CASE NO.: Historic Design Review Case No. HIS23-06

APPLICATION A proposal to replace the existing front walkway. SUMMARY:

LOCATION: 1015 High Street SE

REQUEST: Class 3 Historic Review of a proposal to replace the

### ARABAS L2 SECTION VIEW

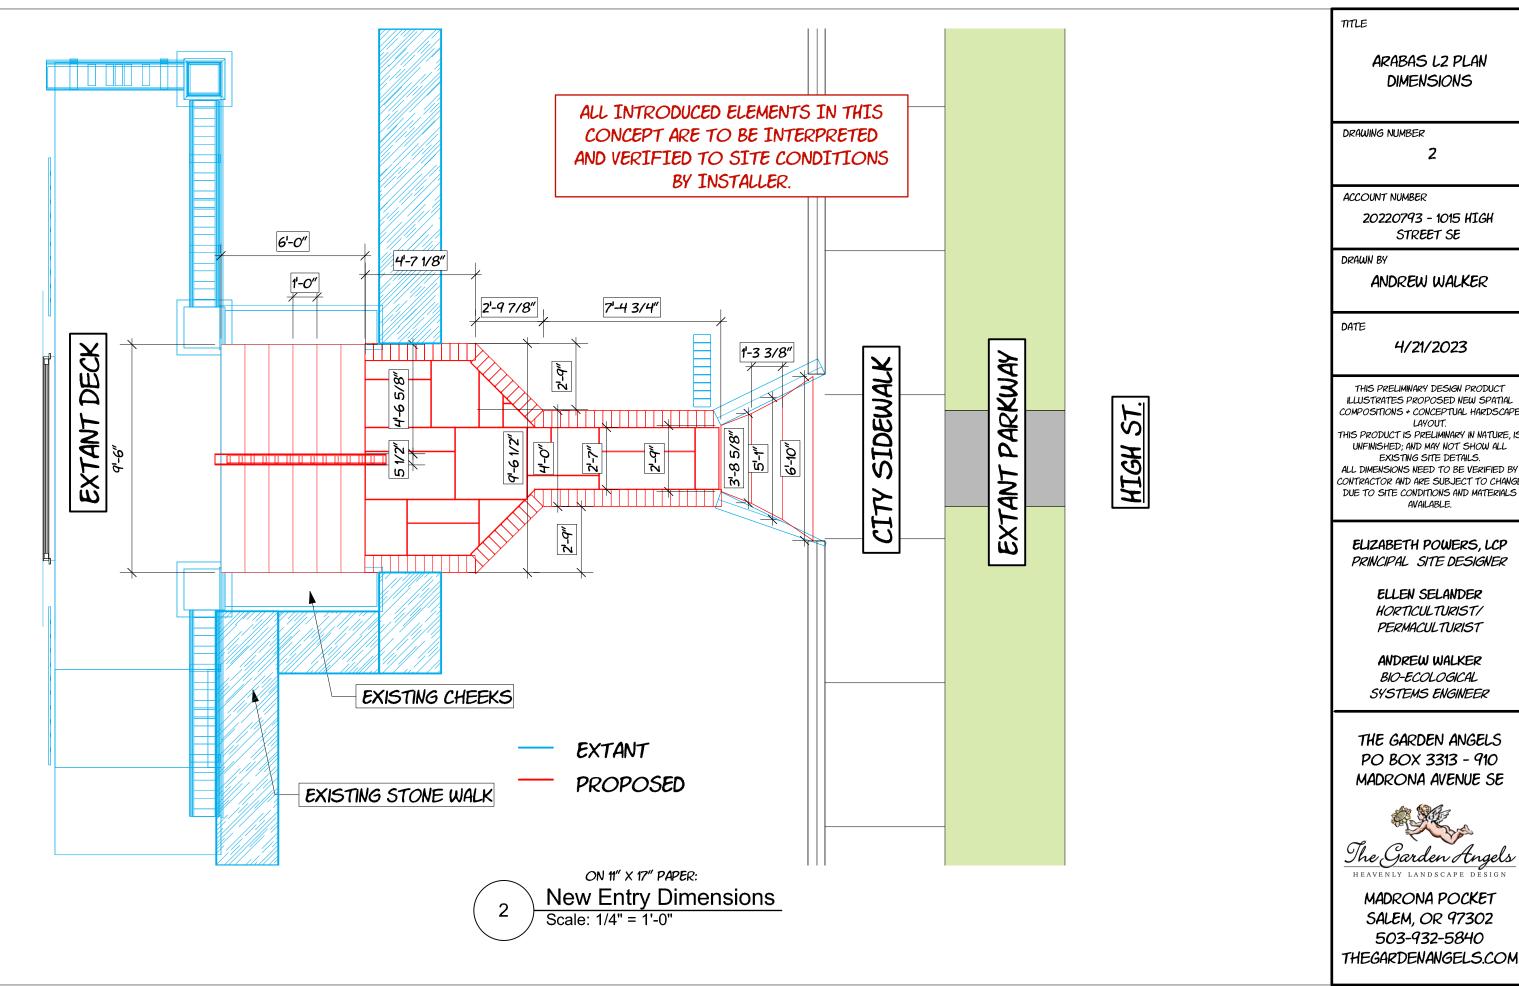
**Findings**: The applicant is proposing to replace the existing non-original flagstone porch steps with new concrete porch steps that reproduce the appearance of the original porch steps. The applicant is proposing to remove the existing non-original central metal handrail on the steps leading to the porch with a new wooden handrail with square spindles reflecting the design of the porch rail. While historic photos confirm that there was no handrail on these steps originally, current building code requires a handrail, and the proposed design and material of the handrail reflects the design and material of the original porch rail. Staff recommends that the HLC find that SRC 230.025(d)(2) has been met.

DETAIL A: ARABAS L2 RAILING

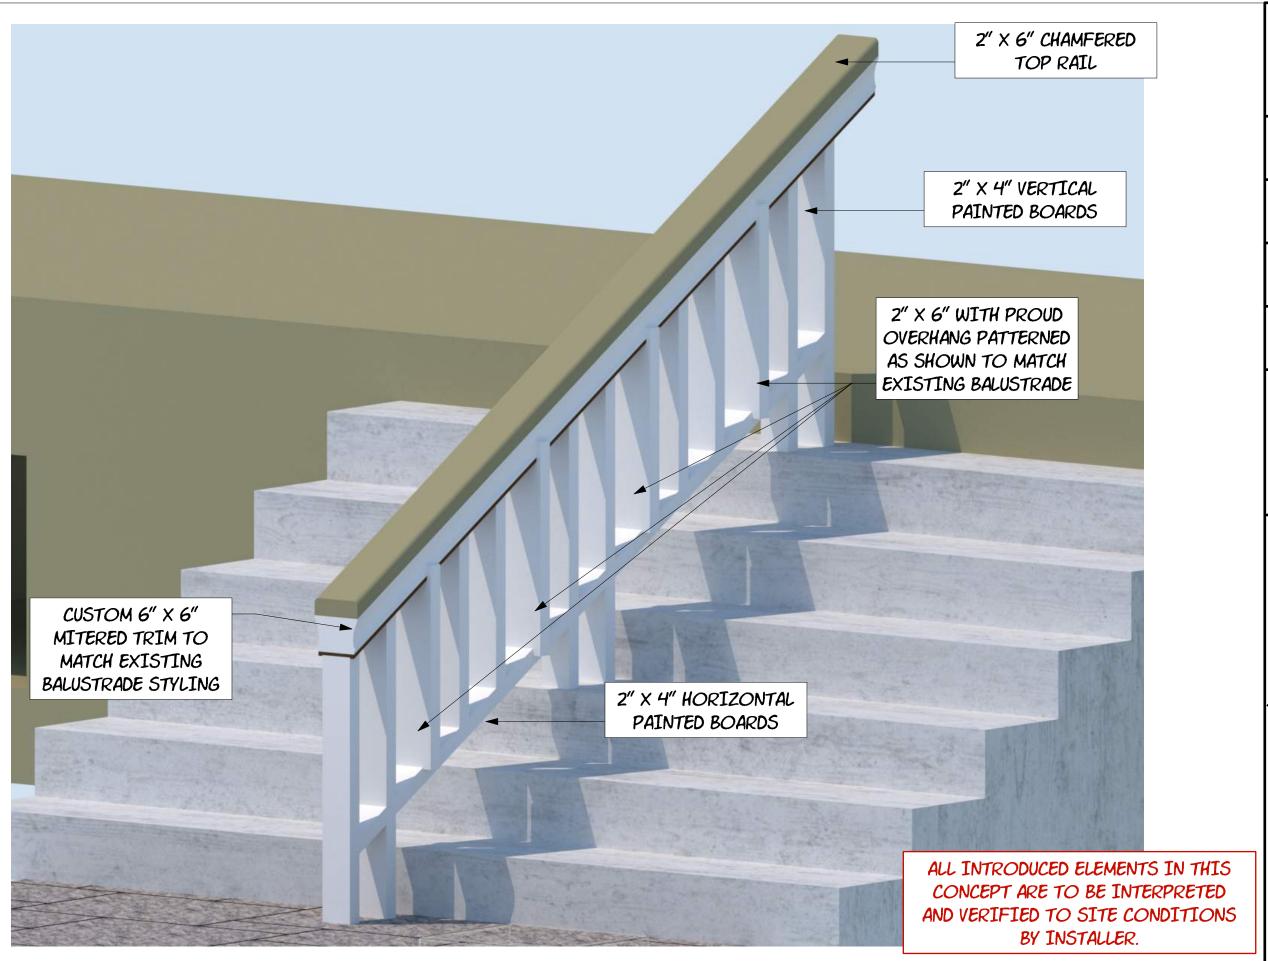
<u>Handrail:</u> Replace non-original metal center handrail with wooden handrail with square spindels reflecting
